AUTHORIZATION OF THE ATLANTIC COAST PIPELINE AND APPROVAL OF RELATED FOREST PLAN AMENDMENTS: OBJECTION

Submitted as comments to the USDA Forest Service by Rick Webb, Program Coordinator, Dominion Pipeline Monitoring Coalition (DPMC), September 5, 2017

The attached maps and text concern the July 2017 Draft Record of Decision (DROD) to authorize construction of the Atlantic Coast Pipeline (ACP) on the Monongahela National Forest (MNF) and the George Washington National Forest (GWNF) and to approve project-specific Forest Plan amendments.

KARST IMPACT MAP 1

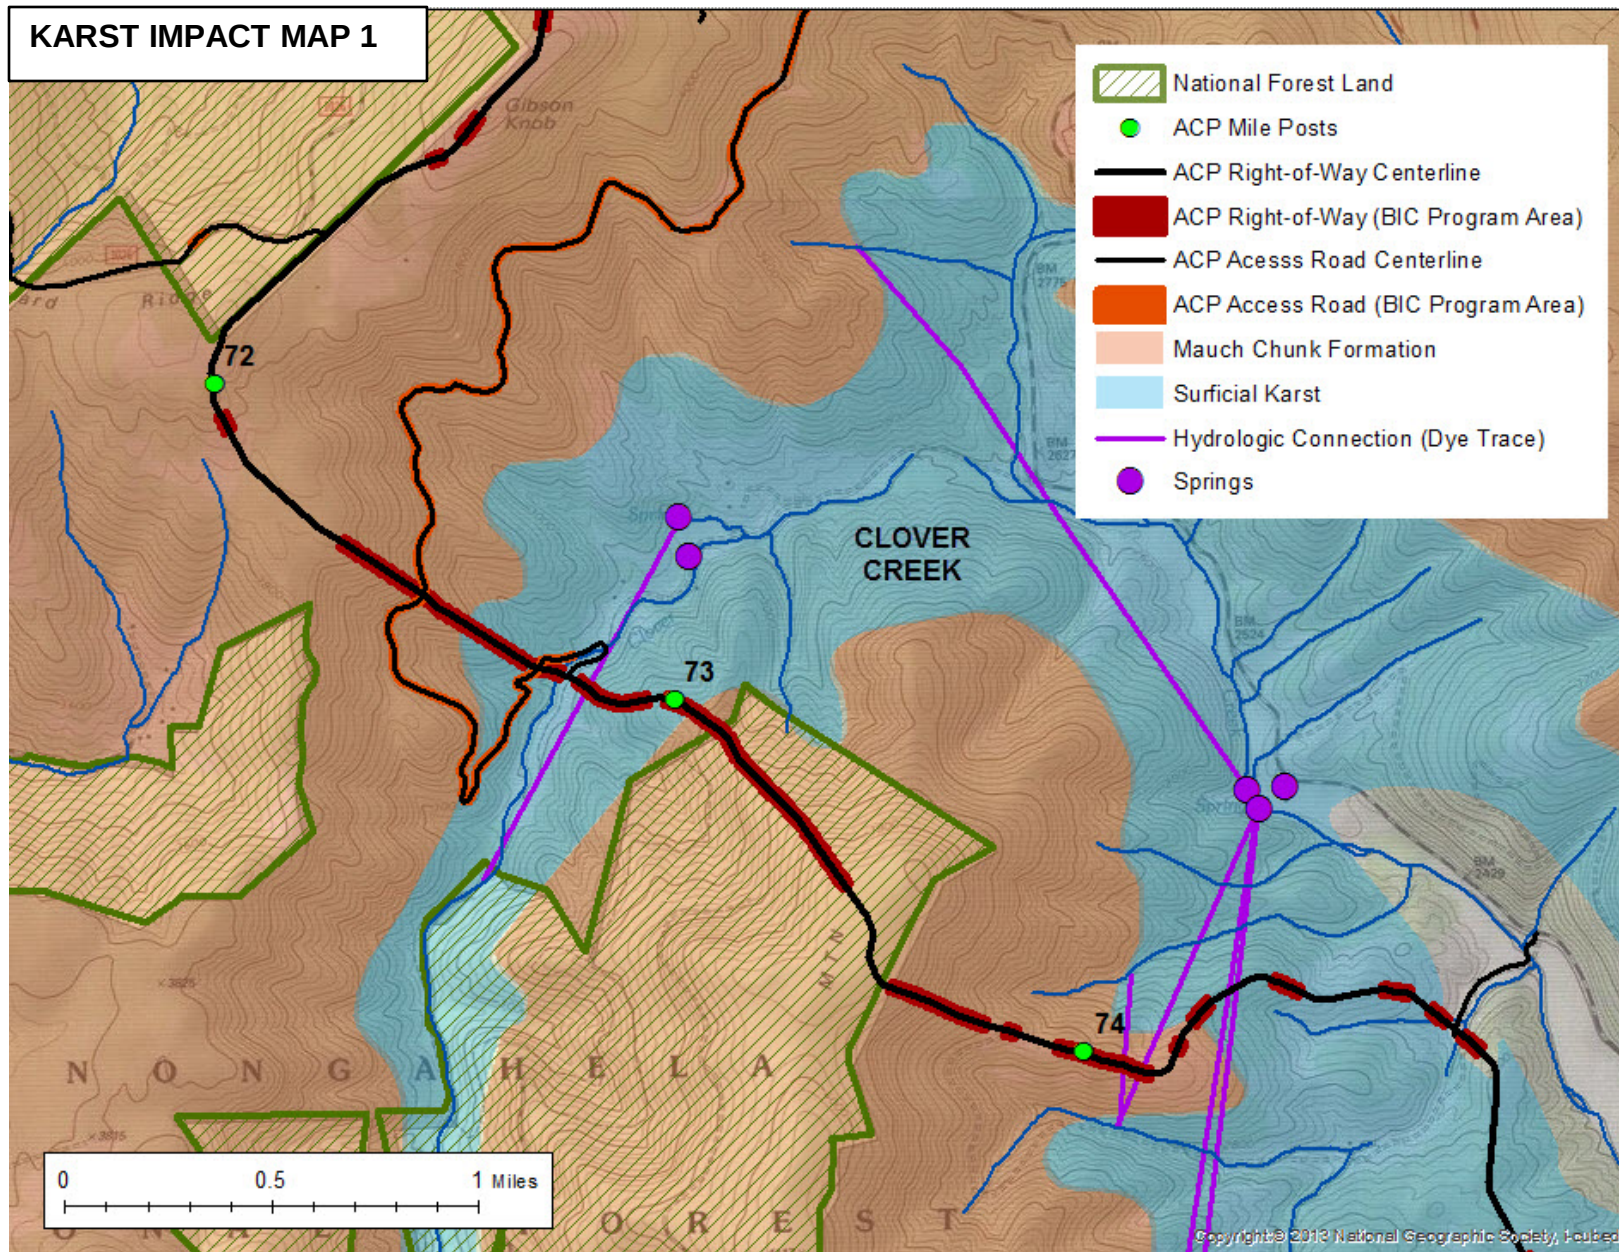
Pipeline and access road construction in the Clover Creek area (see Attachment 3, Karst Impact Maps 1 and 2) involves excavation and disturbance of highly erodible and slip-prone soil with drainage to interconnected karst ground water.

Much of the high-excavation and steep-slope construction on the National Forest in the Clover Creek area will involve the Mauch Chunk formation. The shales and siltstones of the Mauch Chunk form expansive-clay soils that are highly erodible, producing a suspension of clay-sized particles that are slow to settle-out from runoff and receiving waters. The Mauch Chunk also has the highest potential for slippage of any geology found on the MNF.ⁱⁱ Large-scale excavation involving Mauch Chunk soils on steep slopes above and adjacent streams thus presents a high risk of environmental damage and violation of water quality standards.

The presence of the Greenbrier Limestone in the path and downslope of the proposed pipeline and access road corridors in the Clover Creek area presents a high risk of damage to interconnected hydrologic systems. Hydrologic connections have been studied to some extent throughout the larger Mauch Chunk and Greenbrier Limestone area that includes the Clover Creek watershed.ⁱⁱⁱ The karst groundwater connection indicated on the maps in Attachment 3, Karst Impact Maps 1 and 2, is one of many karst groundwater connections that have been identified in or near the pipeline path through the use of dye tracing.

KARST IMPACT MAP 3

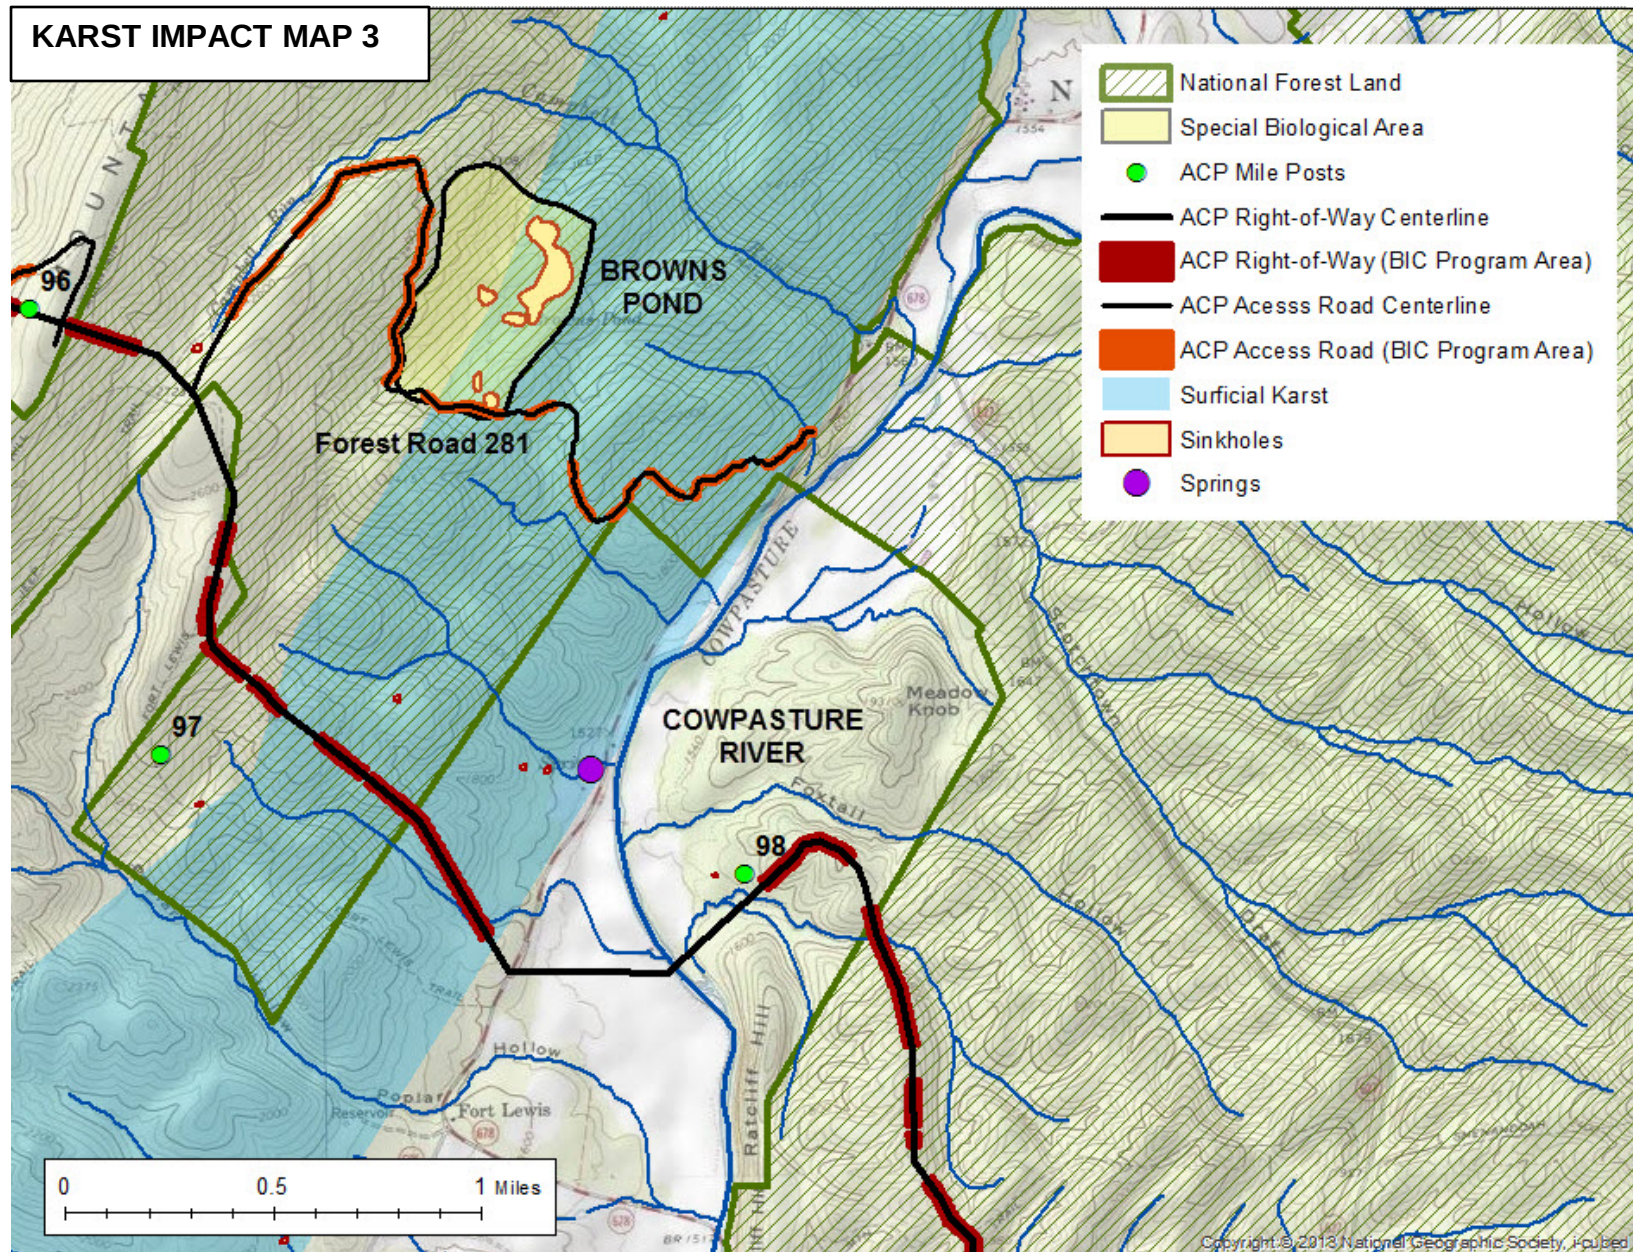
Dominion proposes to “reconstruct” and use Forest Road 281 as an access road. Forest Road 281 drains to and intersects the Browns Pond Special Biological Area (SBA) (see Attachment 2, Karst Impact Maps 3, 5, and 6). As stated in the DROD, Dominion and the Forest Service are “negotiating” the use of this road and the requisite Forest Plan modification (Table 3, page 14). The only issue addressed in the tables supporting information is the issue of the “outstandingly remarkable values associated with the Cowpasture River.” It is remarkable that no mention is made of the risk to the Browns Pond SBA.

Much of Forest Road 281 meets the BIC slope steepness and length criteria (see Attachment 2, Karst Impact Map 3), and site-specific construction plans have not been made available for public review. Other factors also add to the risk to the Browns Pond SBA. As indicated in Karst Map 4, most of the road is located on land classified as “Severe Erosion Hazard.”^{iv} As indicated in Karst Map 5, reconstruction of the route will require an extreme level of excavation. And as indicated in Karst Map 6, the gradient of much of the road exceeds the recommended 16% maximum grades for roads associated with oil and gas infrastructure development.^v

EXTREME EXCAVATION MAP 4

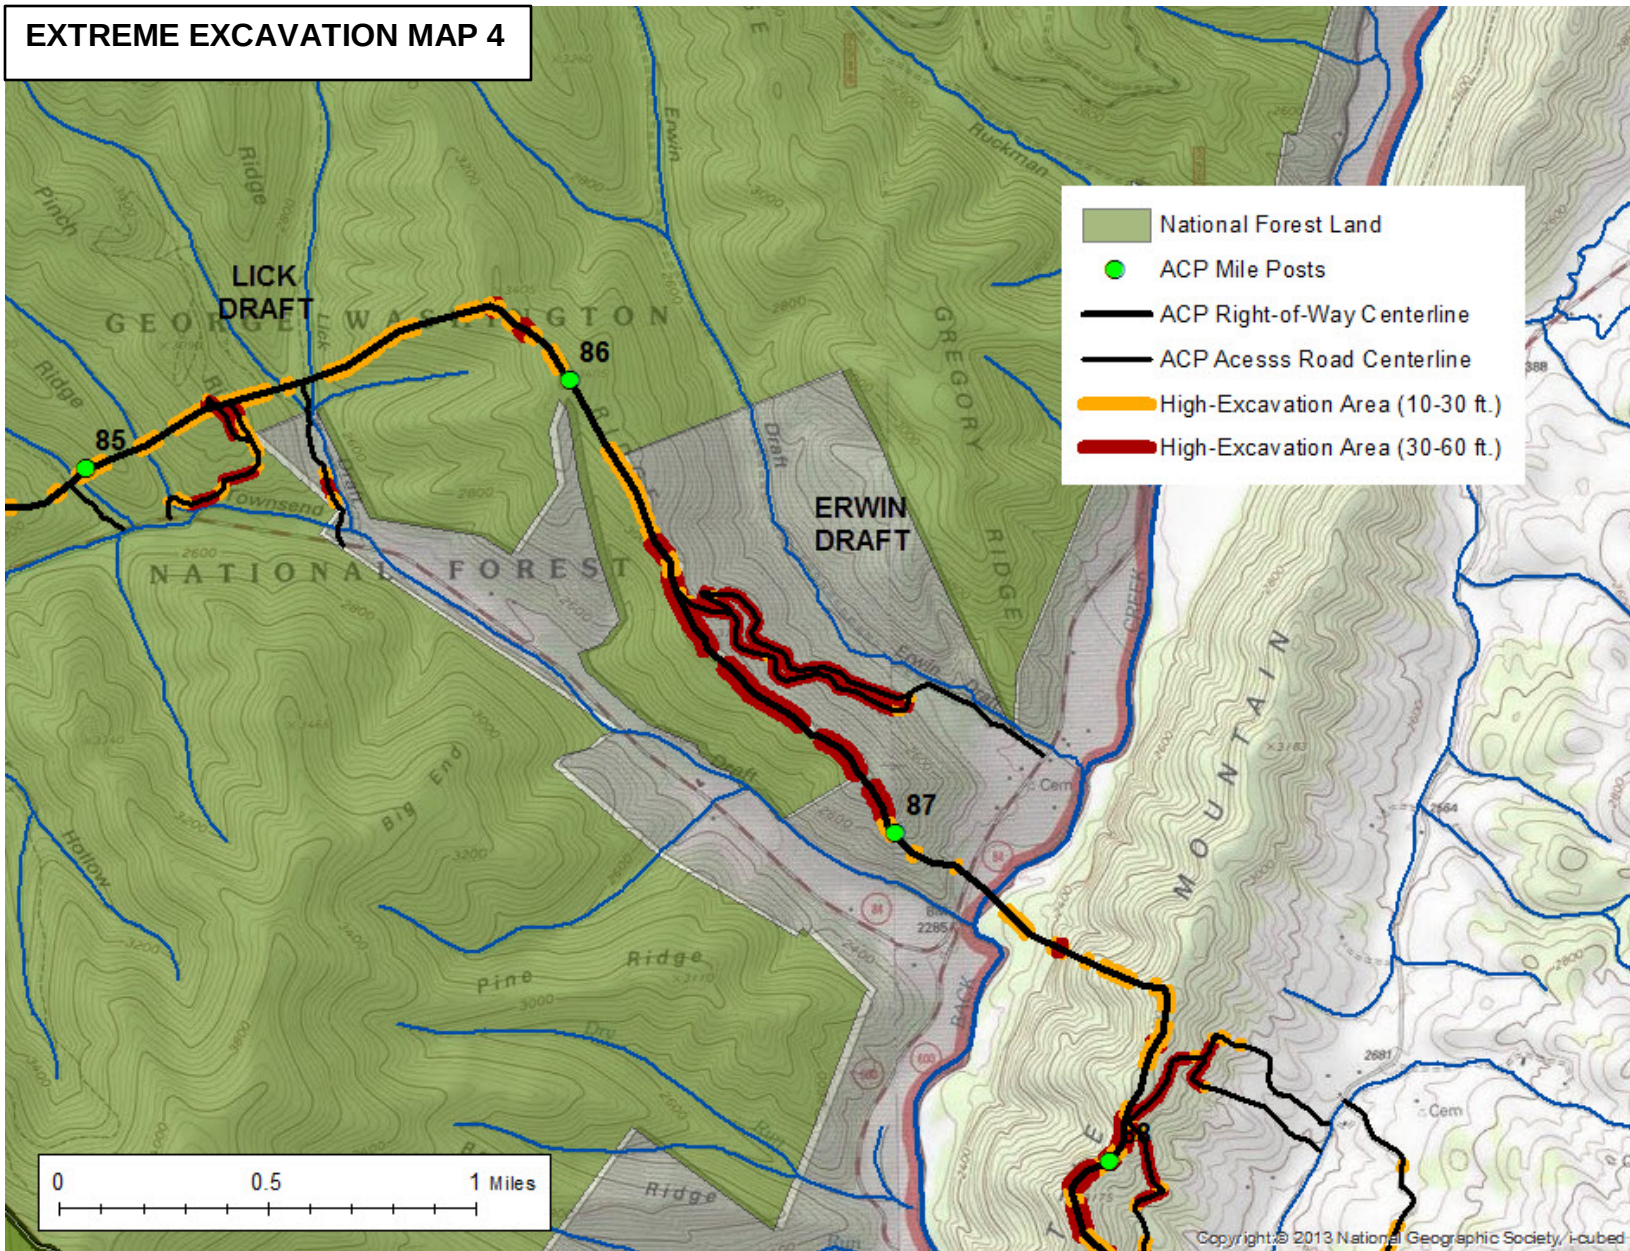
Attachment 4, Extreme Excavation Requirements, indicates the National Forest locations where construction of the ROW and access roads will require significant excavation to create level work space. In the absence of site-specific cross sections and detailed plans for the project, it is assumed that level surfaces of 125 feet for the ROW and 40 feet for access roads will be created through excavation instead of construction with fill. This is a reasonable approximation given the steepness of side slopes on many ridges (see for example, Attachment 4, Extreme Excavation Map 4 and the narrow ridge line between mile posts 86 and 87).
